TOWN OF LUNENBURG

WASTEWATER TREATMENT PLANT UPGRADES & EXPANSION

CONTRACT NO. 240800.00

ADDENDUM NO. 3

PSK01

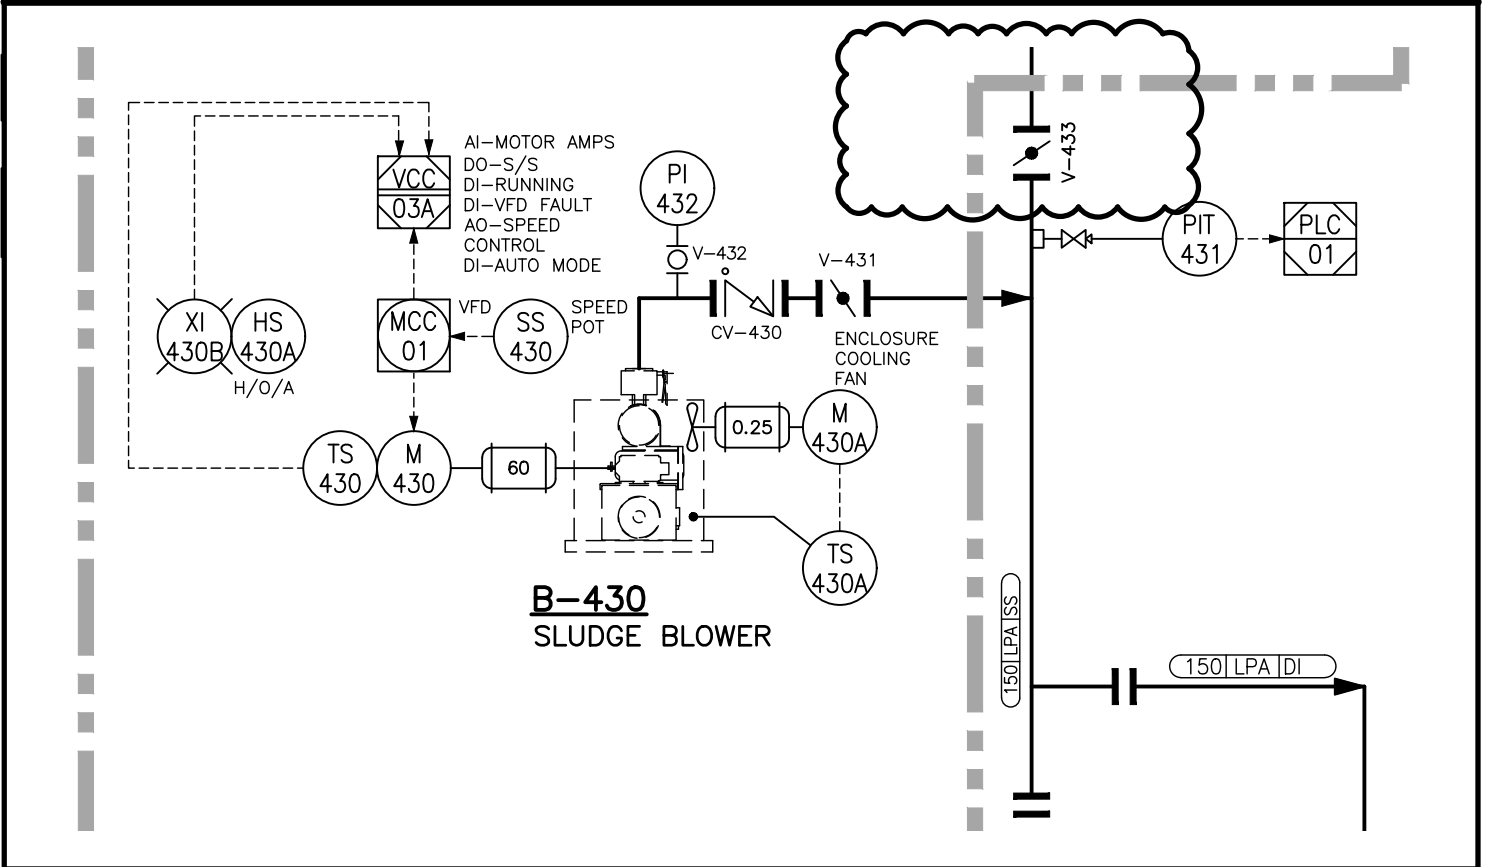
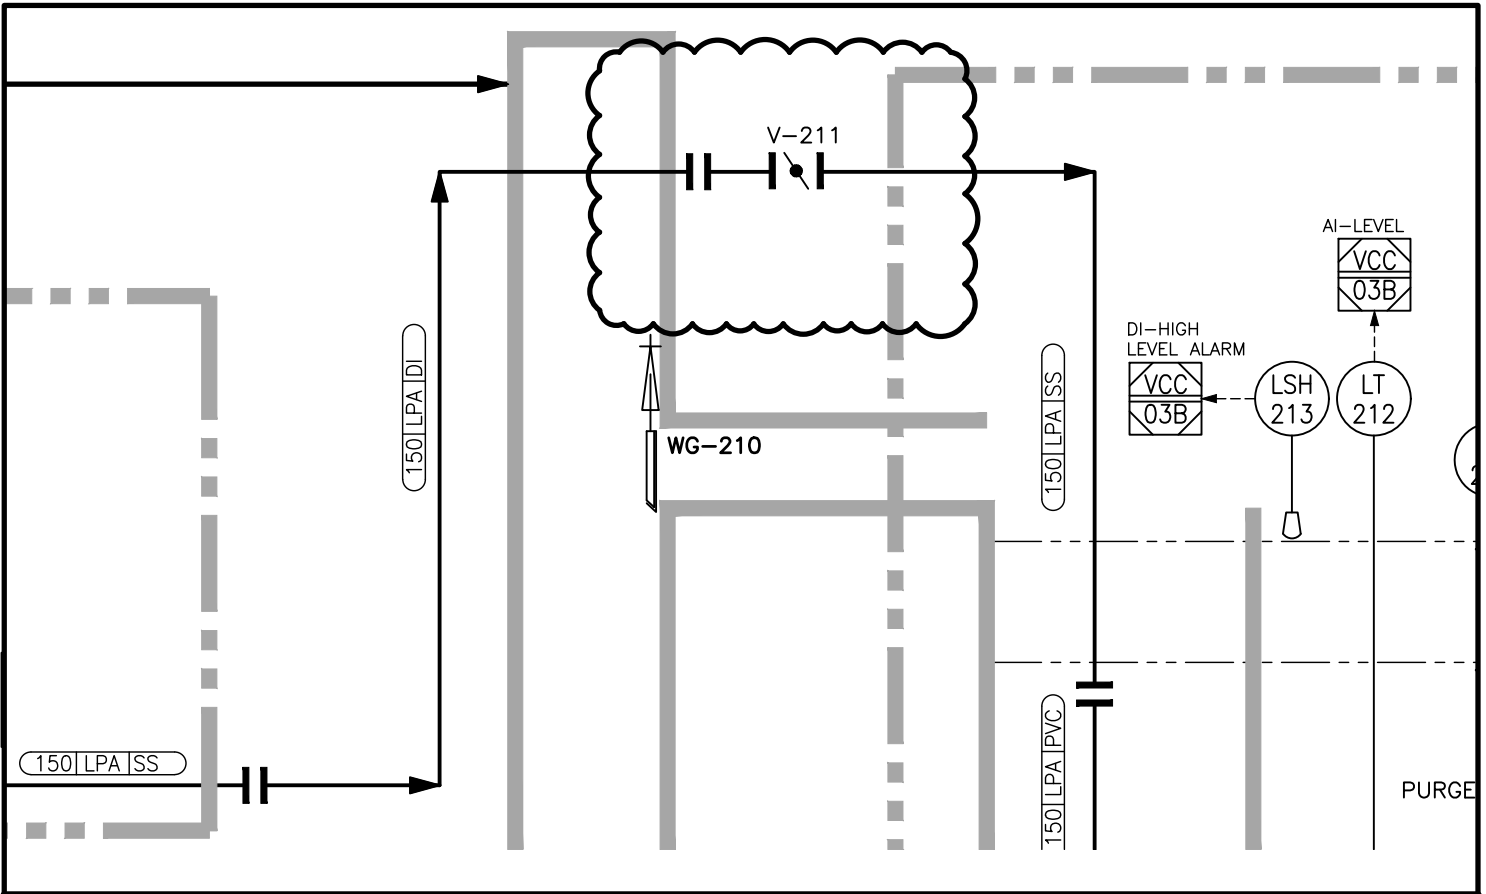
DRAWING P03 – P&ID SHEET 1 OF 3

See attached sketch PSK01, dated February 13, 2025.

PARTIAL P&ID - REFERENCE DRAWING P03

PSK03

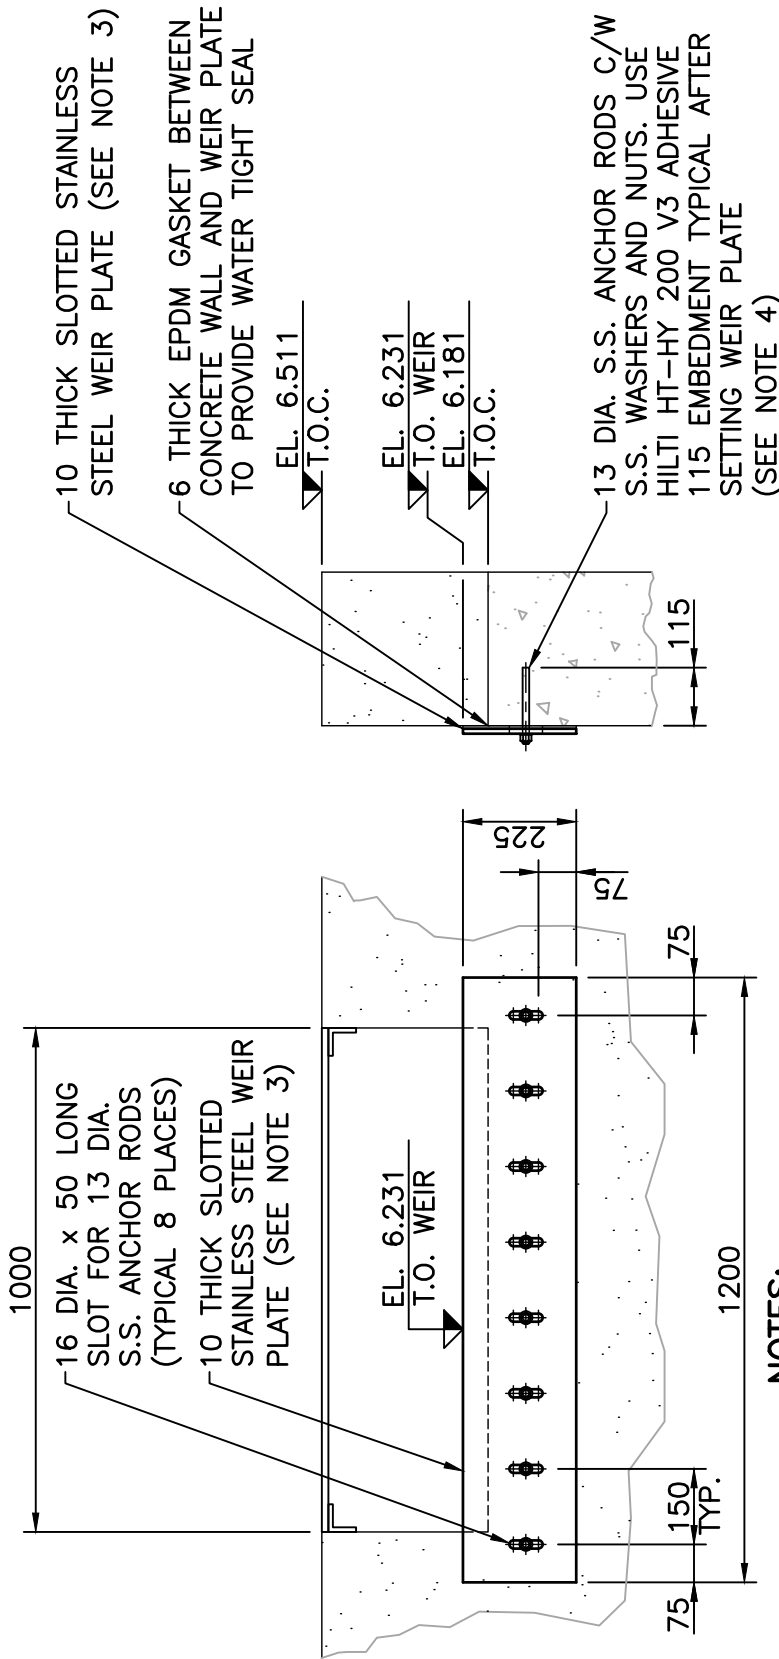
DRAWING P15 – HEADWORKS PLAN, DETAIL AND SECTIONS

PLAN – See attached sketch PSK03, dated February 13, 2025.

CUT 1000 x 330 DEEP HOLE IN CONCRETE WALL FOR OVERFLOW WEIR SEE STRUCTURAL DETAIL

PROPOSED OVERFLOW WEIR SEE S.S WEIR PLATE DETAIL

PSK05

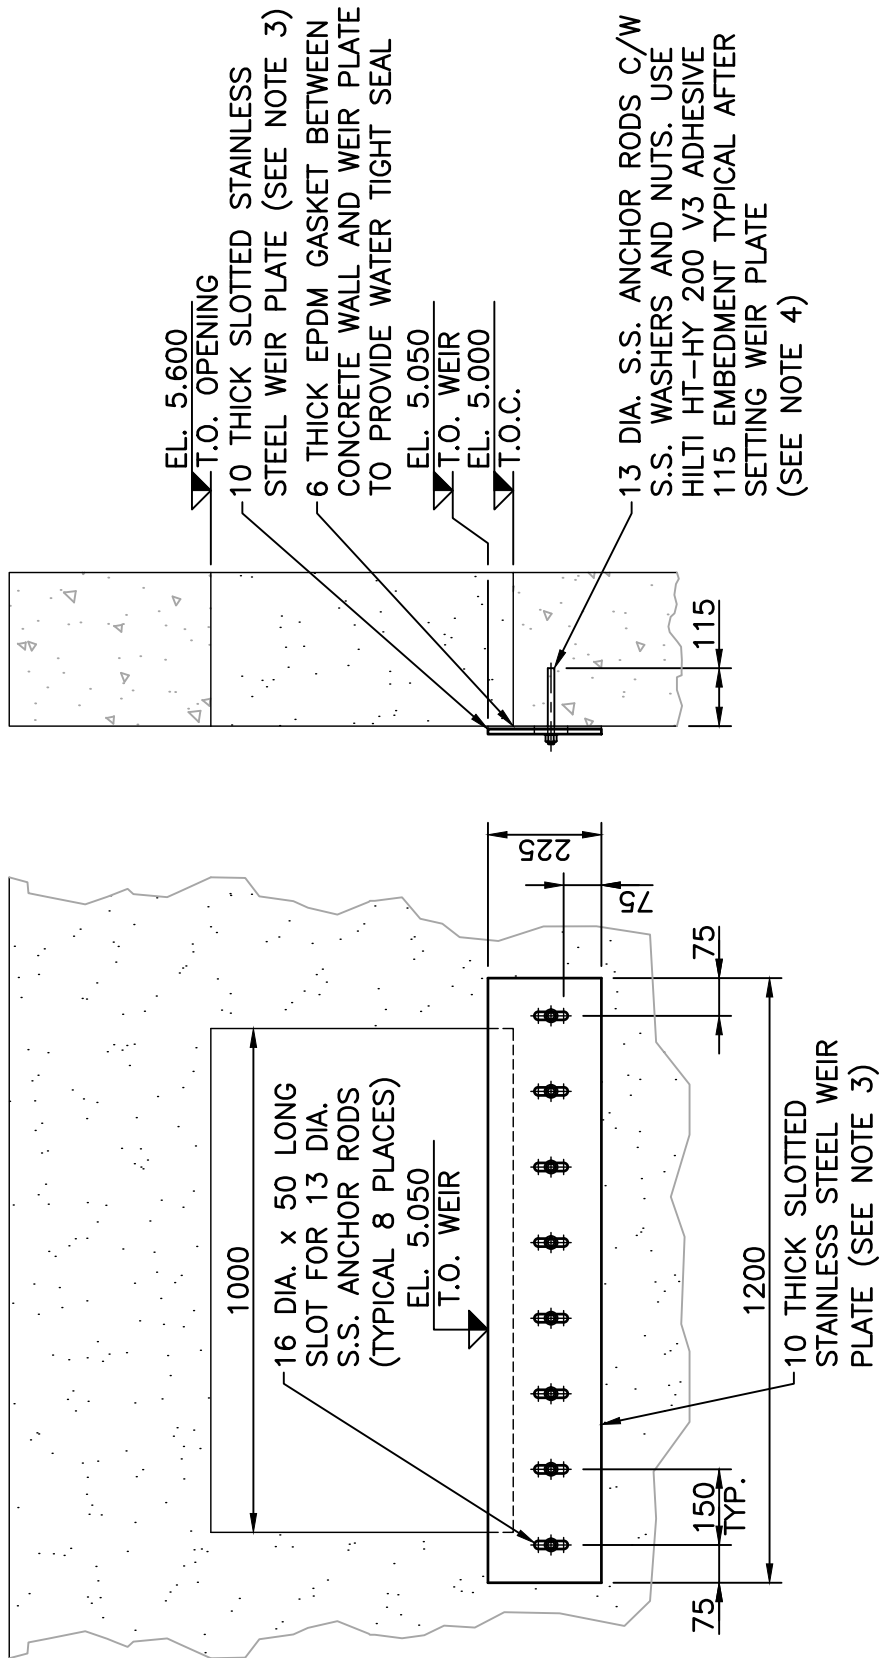
DRAWING P21– SLUDGE HOLDING TANK MODIFICATIONS PLAN AND SECTION

PLAN – See attached sketch PSK05, dated February 13, 2025.
See attached sketch PSK06, dated February 13, 2025.

SLUDGE TANK WEIR SEE
S.S. WEIR PLATE DETAIL

CUT HOLE IN EXISTING
CONCRETE WALL 1000
WIDE x 600 DEEP B.O.
OF CUT OUT AT EL. 5.00
(BELOW PLATFORM) SEE
STRUCTURAL DETAIL
